CORRIGENDUM- 3

Dated: 06.11.2023

The amendments and clarifications regarding Bidding document no. 31/CE/PLG/RGTPP/FGD-250 (Tender ID: 2023_HBC_307531_1) for Wet Limestone based FGD System Package for RGTPP, Hisar (2x600MW) in respect of queries raised by the bidders are attached as Annexure-A (Amendments) and Annexure-B (Clarifications) respectively.

**FGD System Package for RGTPP, Hisar (2x600 MW)
Bidding Document No: 31/CE/PLG/RGTPP/FGD-250
Amendment No: 31/CE/PLG/RGTPP/FGD-250-Amndt.-01**

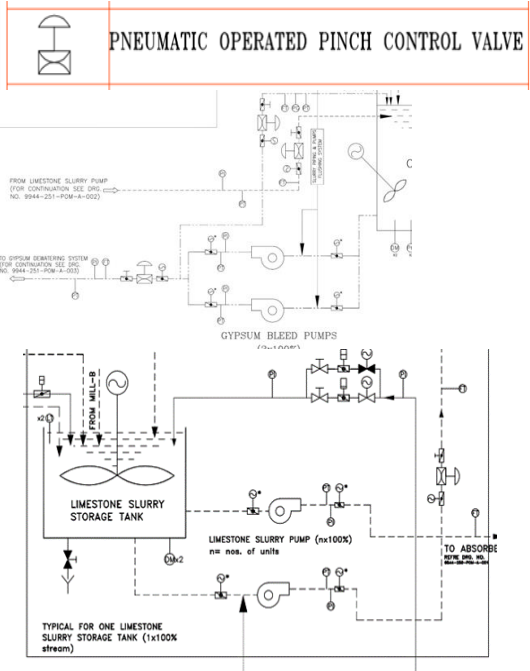
81.	SECTION – VI, PART-A	SUB-SECTION-III-A1 FGD	7.03.00	PAGE 6 of 10	Two (2) clarified water Storage tanks (each tank catering to the clarified water requirement for one vacuum Belt Filter) along with two numbers of 2x100 % clarified Booster water pumps, if required, from terminal point.

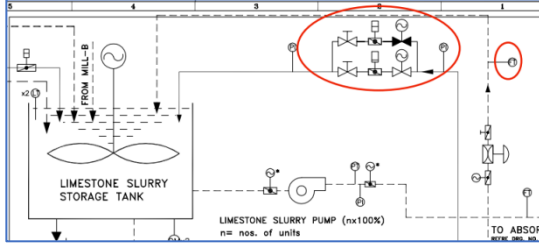
96.	SECTION-VI PART A PART E	SUB-SECTION-III A1 (FGD) Scheme of Gypsum Dewatering Drg no.	5.04.00	5 of 10	The filtrate water from belt filter dewatering and wash water from washing system and the underflow from the secondary hydro-cyclone shall be taken to a common filtrate water tank. 2x100% pump shall be provided to supply wash water (for cake washing as	'Bidder would like to inform that Filtrate water is not suitable for cake washing and belt cloth washing. Clarified water shall be provided for cake washing as per clause no. 7.04.07 mentioned in Technical Specification Section-VI Part B Sub section I M1 (FGD)	Bidder to refer Note-2 of the drawing no. 9944-250-POM-A-003 i.e. "Arrangement for cake and belt/cloth washing system indicated is typical. Contractor may offer an alternate system as per his proven practice".

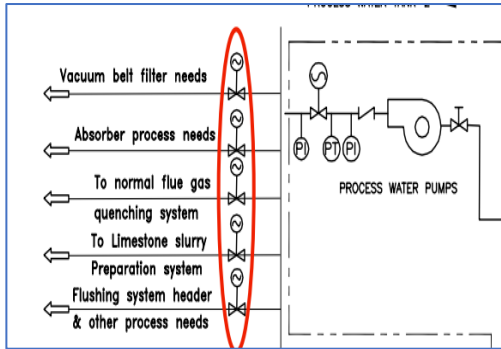
118.	SECTION-VI PART B	SUB- SECTION-I- M1(FGD)	5.06.07	18 of 52	The absorber oxidation tank shall be provided with an over flow line (for spray tower process) complete with sealing	Bidder would like to inform that seal loop shall be provided as per Bidder's proven practice. Bidder does not envisage seal pot	Bidder to comply the specification requirement.

Sr. No	SPECIFICATION REFERENCE				SPECIFICATION REQUIREMENT	BIDDER'S QUERIES	HPGCL REPLY
					pot, over flow and drain line.	design for Absorber overflow line as it leads frequent choking and Bidder shall provide overflow line arrangement per Bidder's proven practice.
